**Subject: Information on Proposed Changes for the AP1000 Design Control Document Rev. 18**

Description of Proposed Changes for AP1000 DCD Rev. 18, Non-Proprietary

## Change No. 64

## Change No. 66

Figure 2.2.1-1  
Containment System

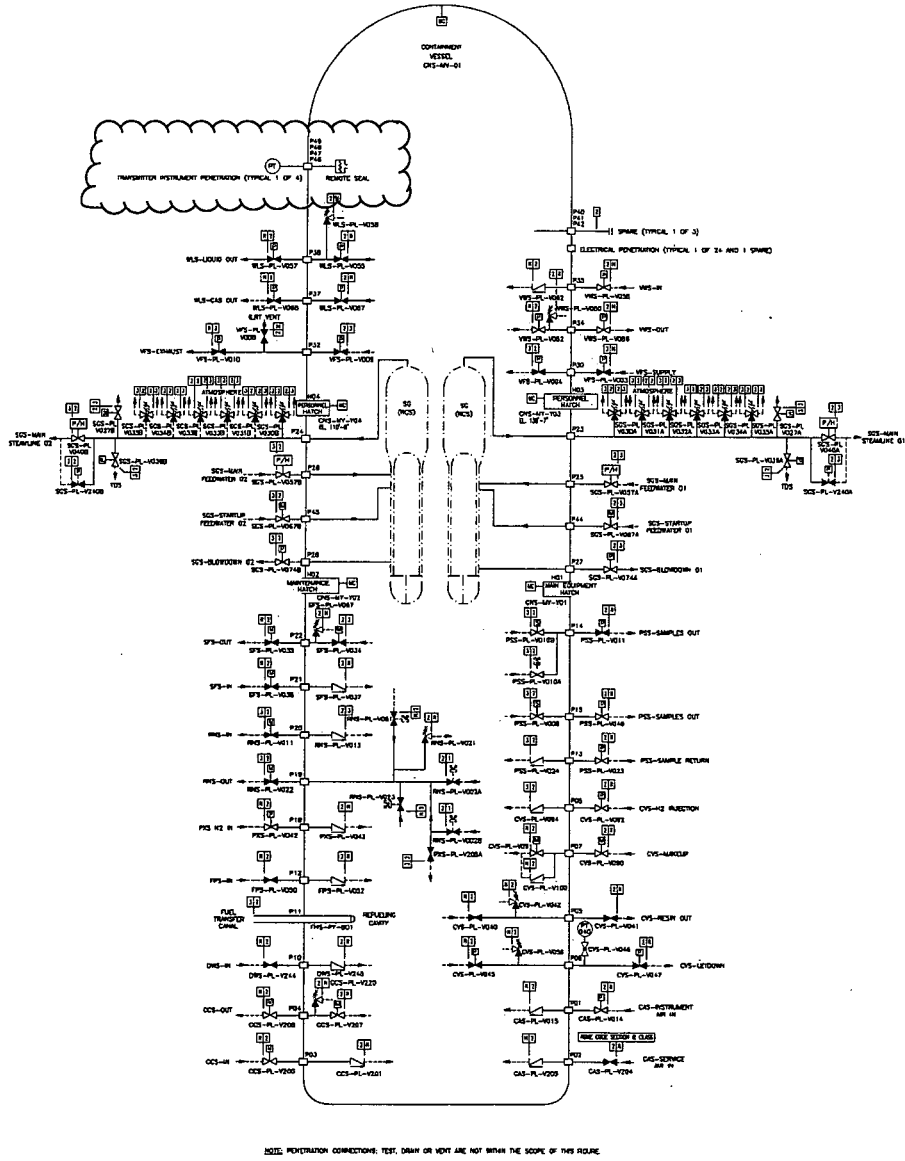
<b>Subject</b>
Changes to Post-DBA Transmitter Requirements
<b>DCD Sections Impacted</b>
Tier 1: Table 2.2.1-1, Figure 2.2.1-1, and Table 2.2.2-1. Tier 2: Appendix 1A (pages 1A-3, 1A-63), Chapter 3 (page 3.1-31, Table 3.2-3 (sh 13/69), Section 3.8.2.1.7, Figure 3.8.2-4 (sh 4/6), Table 3.11-1 (sh 13, 14/51), and Table 3D.4-2), Chapter 5 (Figure 5.1-5 (sh 1, 2/3), Chapter 6 (Sections 6.2.1.1.3, 6.2.1.7, 6.2.2.3, 6.2.3.1.1, 6.2.3.3, and Figure 6.2.2-1 (sh 1/2)), Table 7.5-1 (sh 3/12), Appendix 9A (Sections 9A.3.1.1.2, 9A.3.1.1.3, 9A.3.1.1.7, 9A.3.1.1.8, 9A.3.1.1.9, 9A.3.1.1.14, 9A.3.1.1.15, 9A.3.1.3.1.1, and Table 9A-2 (sh 1, 2, 3, 5, 7, 8/14)), and Tech Spec Bases 3.3.2
<b>Description of change to DCD/Reason for change to DCD</b>
<u>Description of DCD Change:</u> There are numerous changes to the DCD that support the three main design changes.
<u>Description of Design Change:</u> There are three main design changes;

<p>A. Move 7 Containment Pressure Transmitters outside containment, and connect to remote pressure sensors inside containment by sealed capillary tubing. This change requires the addition of four new containment penetrations, one for each safety division. In divisions A, B and C, the normal-range and wide-range transmitters share one capillary line and penetration. For division D there is no wide-range transmitter, so the normal-range transmitter is on its own capillary.</p> <p>In choosing proposed transmitter and penetration locations, separation between safety divisions was maintained. Division A &amp; C Containment Pressure Transmitters will be located in the VFS Penetration Room (Room 12452) which is in Fire Zone 1200 AF 01. Division B &amp; D Containment Pressure Transmitters will be located in the Middle Annulus (Room 12341) which is Fire Zone 1200 AF 12341. Penetration P46 (Division A) and Penetration P48 (Division B) will be 27 inches apart, which is greater than the 18" minimum separation requirement by ISA 67.02 for redundant instrument sensing lines. Similarly, Penetrations P47 (Division C) and P49 (Division D) will also be 27 inches apart.</p> <p>Routing and protection of the containment pressure instrumentation capillary lines as they pass through the middle annulus between containment and the auxiliary building wall will be addressed in the same way as for fluid system piping and tubing. The capillary lines are Seismic Category I, and will be routed and supported accordingly. For these lines, as well as for fluid system lines penetrating containment, routing and support design and analysis will take into account both the relative seismic displacement and displacements caused by temperature and pressure changes. The proposed locations for the containment pressure transmitters are outside of the zone of influence of any postulated high energy line break. The capillary tubing will also be protected from incidental damage that could result from maintenance activity in the surrounding area. The instrumentation is not in an area subject to the movement of heavy loads. There are no other known causes of common mode failure that must be considered.</p> <p>Because there were previously no instrument penetrations in the AP1000 design, the basis for conformance to Regulatory Guides 1.11 and 1.151 is revised. Conformance with Regulatory Guide 1.11 is updated to reflect recent issuance of revision 1. Details are added in DCD Chapters 1, 3 and 6 to demonstrate conformance with Regulatory Guide 1.151.</p>

Figure 3.8.2-4 (Sheet 4 of 6)

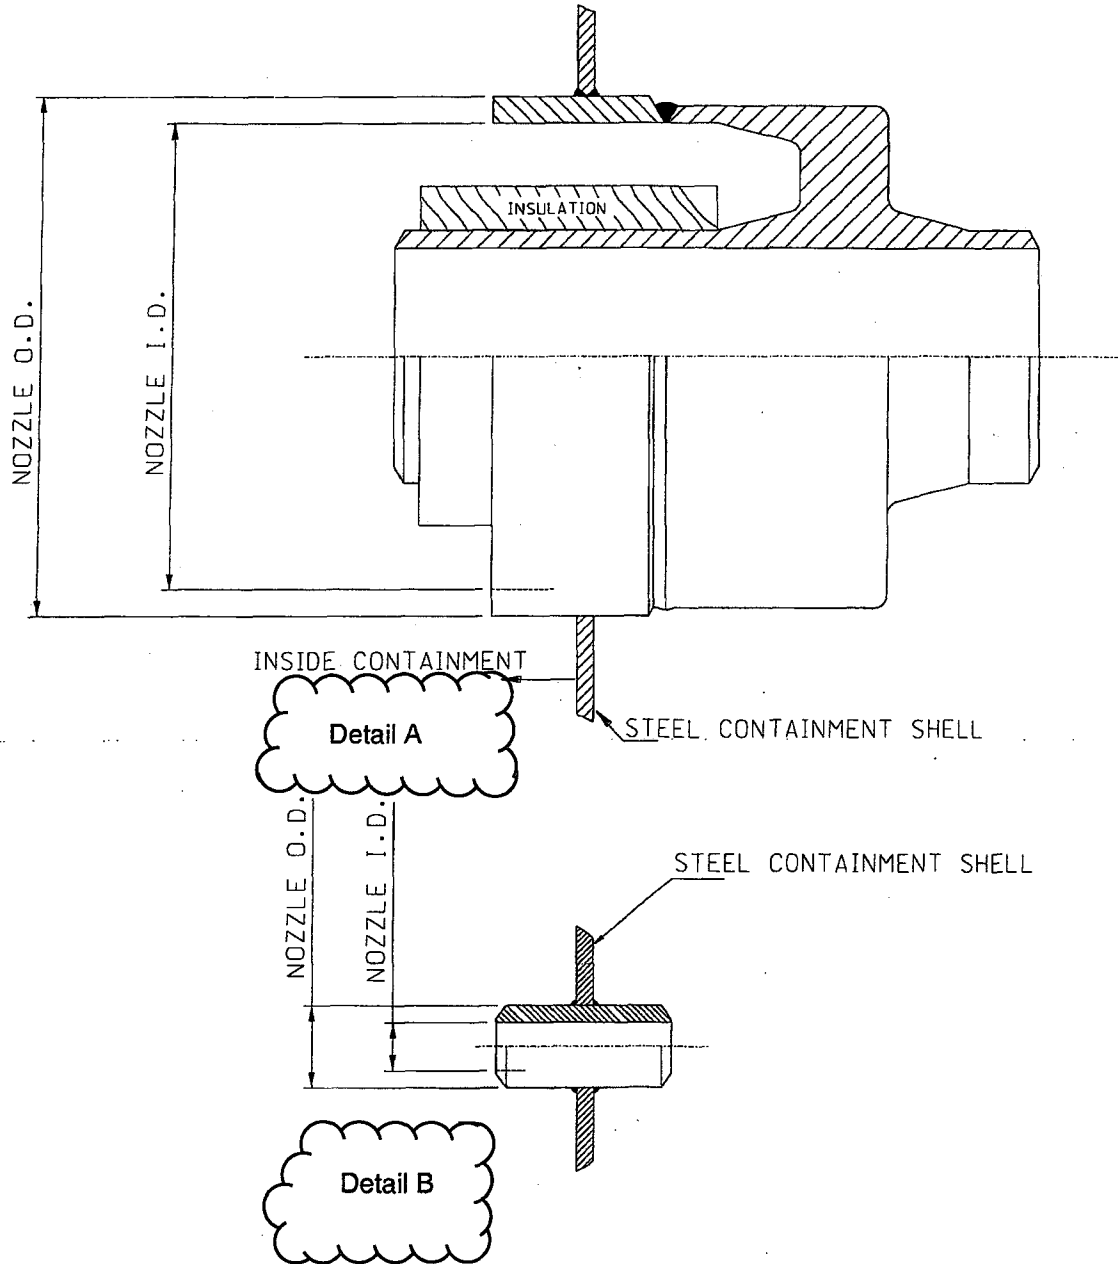
Figure 3.8.2-4, sheet 4, detail B, shows typical details for the containment pressure instrumentation penetrations. The penetrations consist of sleeves welded to the containment vessel. Pressure transmitters outside containment are connected to pressure sensors inside containment by sealed, fluid-filled tubing (capillary), which passes through the sleeves. The capillary tubing is welded directly to the sleeve at a tubing coupling, which has a thicker wall and larger diameter than the capillary tubing.

Inside Reactor Containment  
Figure 5.1-5 (Sheet 1 of 3)

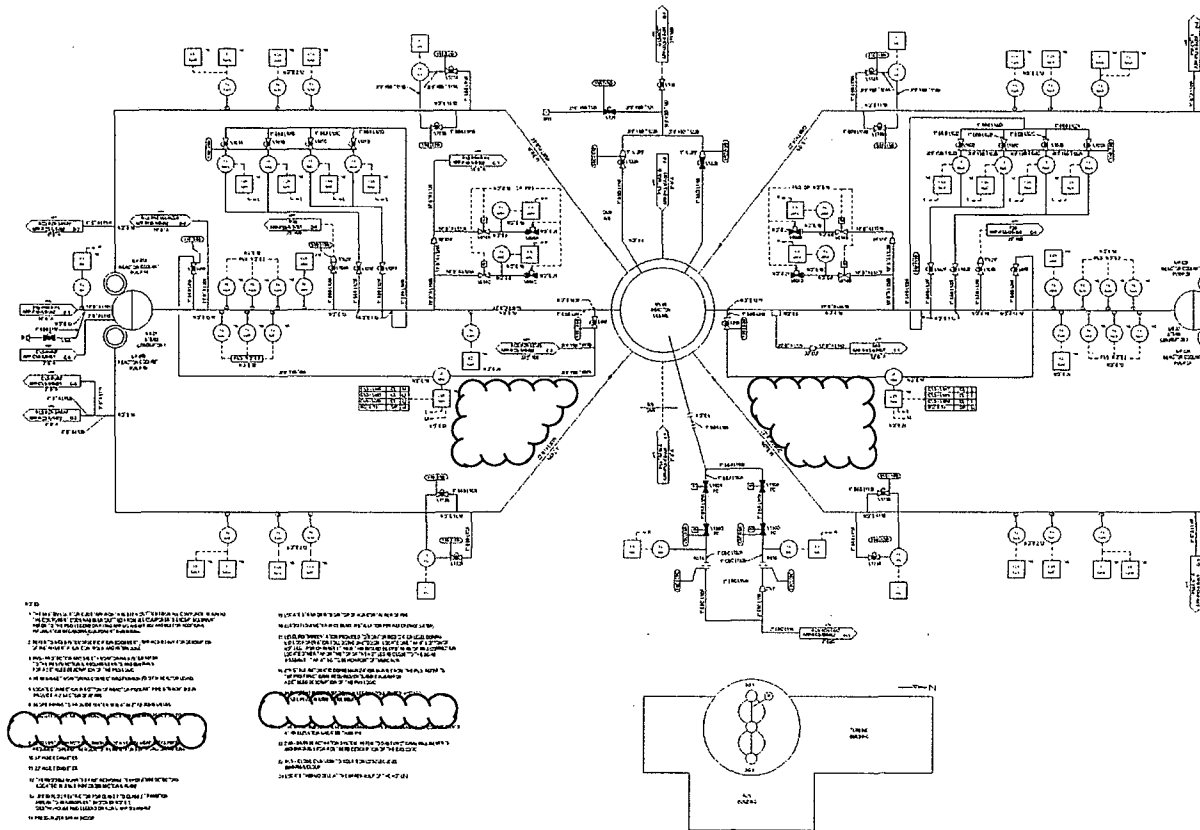
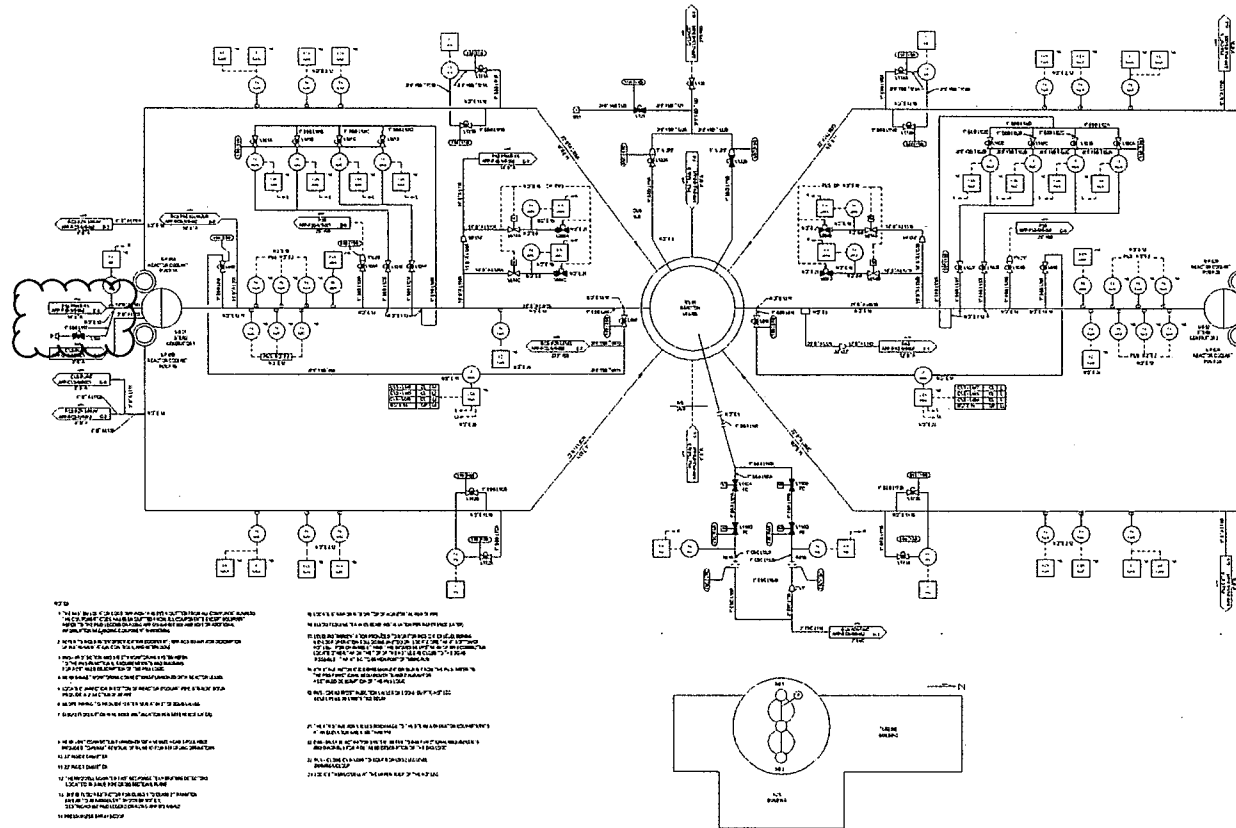
Table 3.11-1; Add non-active valves to the list of environmentally qualified electrical and mechanical equipment
Table 3I.6-3; Add valves to the list of mechanical equipment not sensitive to high frequency
Figure 5.1-5 (sh 1/3); add manual maintenance drain valve in line from PRHR heat exchanger to steam generator
Figure 6.3-1 Sheets 1 and 2; See P&ID Markups, DCP Figures 5 and 6, with enlarged excerpts in DCP Figures 7 through 22.
Section 16.1, Technical Specifications

Figure 2.2.3-1 (Sheet 2 of 2)  
Passive Core Cooling System

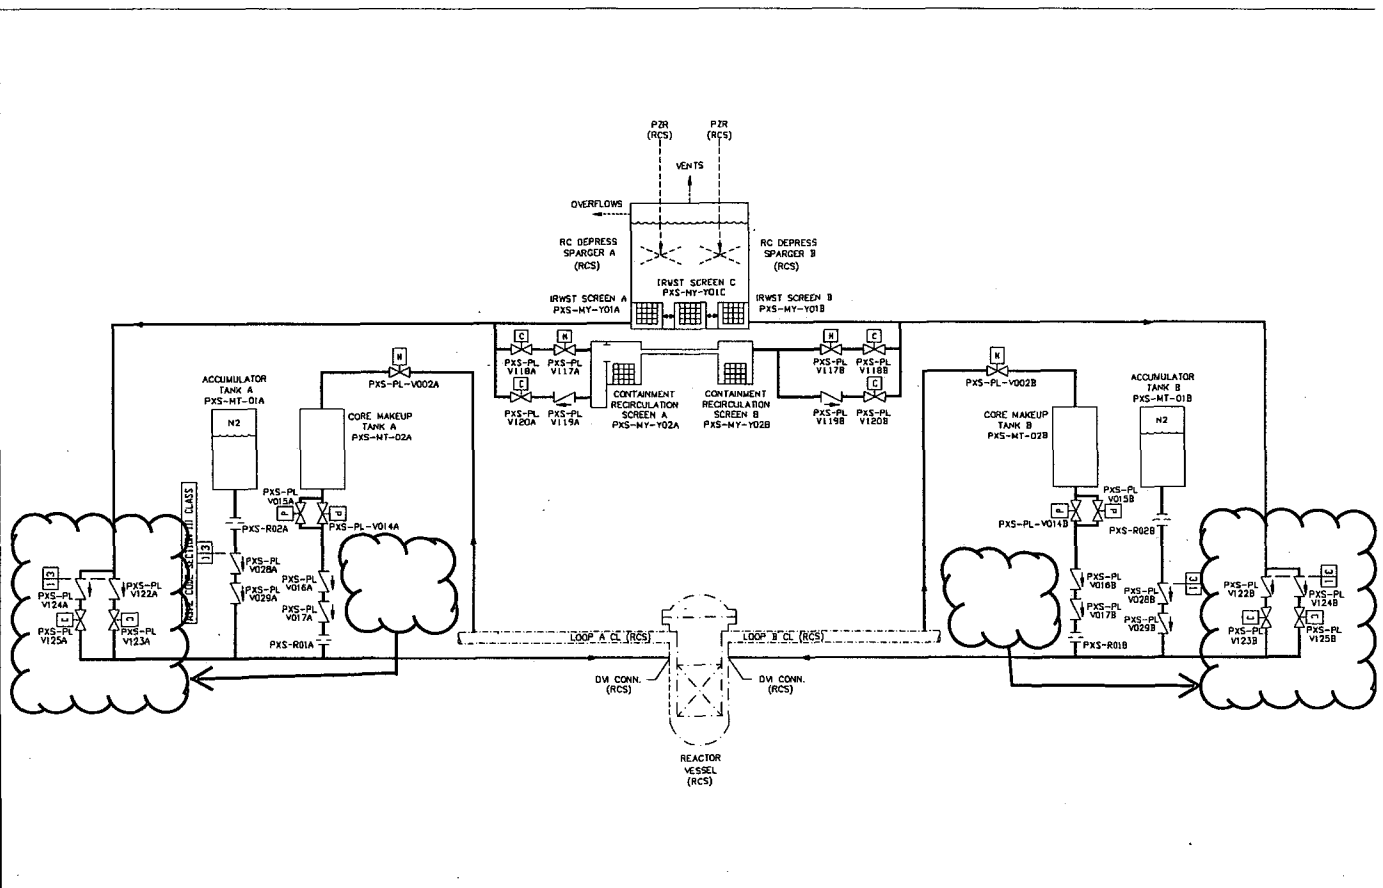
<b>Subject</b>
Passive Core Cooling System (PXS) Changes due to Gas Accumulation
<b>DCD Sections Impacted</b>
Tier 1: Figure 2.2.3-1 (sh 2/2)
Tier 2: Table 3.2-3 (sh 17, 20, 21, 22, 27, 33/69); Table 3.9-17; Table 3.11-1 (sh 34, 36, 37, 38, 40, 43/51); Table 3I.6-3 (sh 14, 17, 18, 20, 23/32); Figure, 5.1-5 (sh 1/3), Figure 6.3-1 (sh 1), Figure 6.3-2 (sh 2); Section 16.1 Technical Specifications: LCO 3.5.6, LCO 3.5.7, LCO 3.5.8, B 3.5.6, B 3.5.7, B 3.5.8
<b>Description of change to DCD/Reason for change to DCD</b>
<u>Description of DCD Changes:</u>
Tier 1: Figure 2.2.3-1; This figure change includes moving the location of the IRWST injection paths to the outside of the figure and raising the IRWST and associated piping such that a solid line of flow could be shown to the IRWST injection isolation valves.
Tier 2:
Table 3.2-3: Add new Class A/B/C vent valves to table list for PXS;
Table 3.9-17; Update entry in Tech Spec Column for IRWST

B 3.5.8, SURVEILLANCE REQUIREMENTS: Add Noncondensable Gas Surveillance Requirements for IRWST High Point Vents
<u>Description of Design Change:</u>
This design change is being made to PXS injection lines to address gas intrusion concerns and design finalization by:
<ul style="list-style-type: none"> <li>• Adding eight (8) manual maintenance vent valves in six (6) PXS passive injection and recirculation line piping high point locations</li> <li>• Adding four (4) pipe stubs with maintenance vents and associated valves, line routing to tee into CMT vent line routing to the RCDT, and remote pipe stub gas void indications at the outlets of each of the IRWST passive injection</li> </ul>

- Re-routing the two (2) accumulator discharge line connections to both DVI line vertical cold trap (riser) pipes to tee in physically above (in elevation) and downstream of the associated IRWST connection into the DVI riser pipes, instead of having the accumulator connection be upstream of and below the IRWST tee
- Adding twenty (20) manual maintenance drain valves in fourteen (14) PXS passive injection and recirculation piping locations, five (5) RNS piping locations, and one (1) RCS piping location (the RNS and RCS drains are unrelated to gas intrusion effects but part of design finalization to consolidate required PXS line changes and piping analyses)

Figure 6.3-2

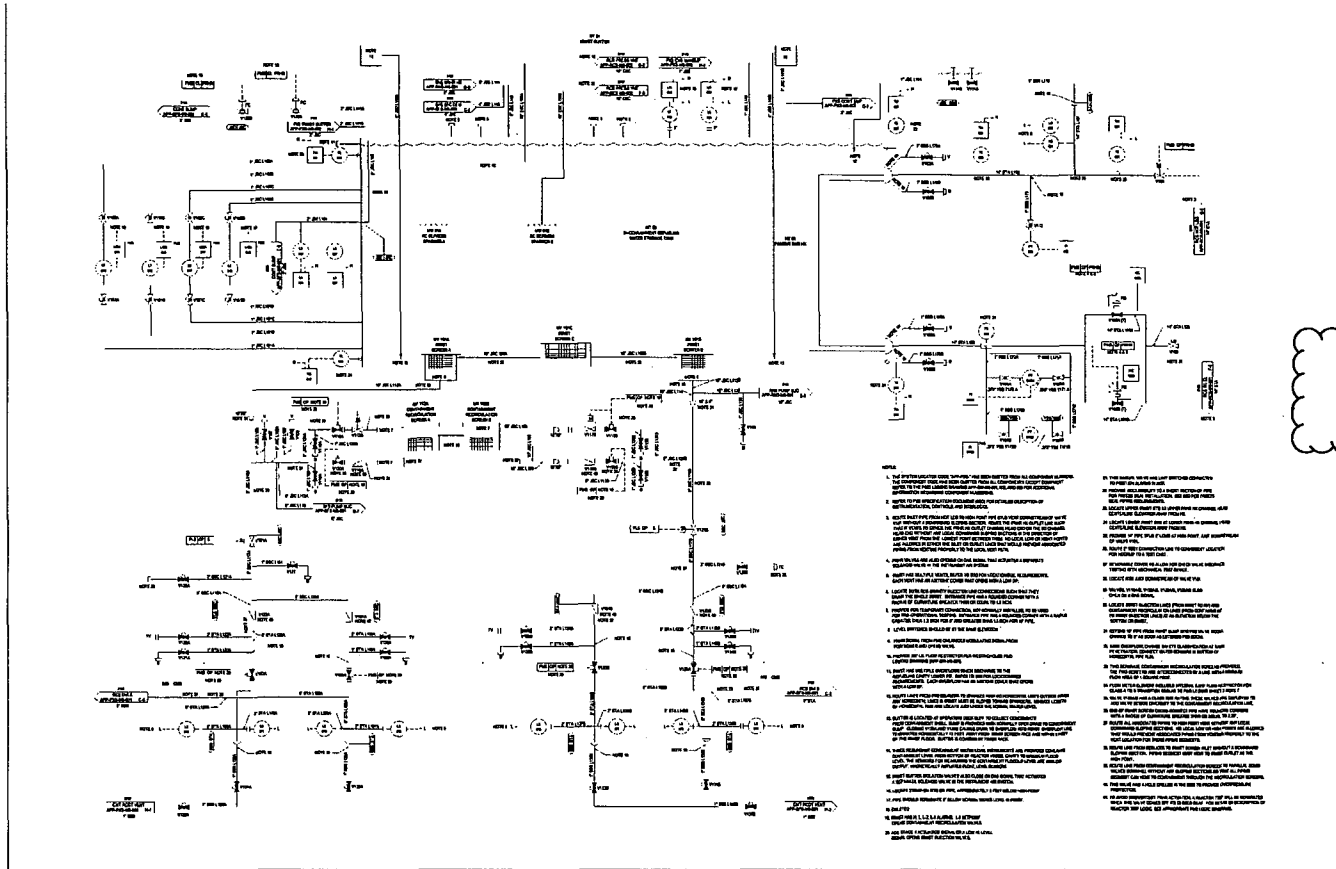
Information on DCD changes found in enclosure 6.
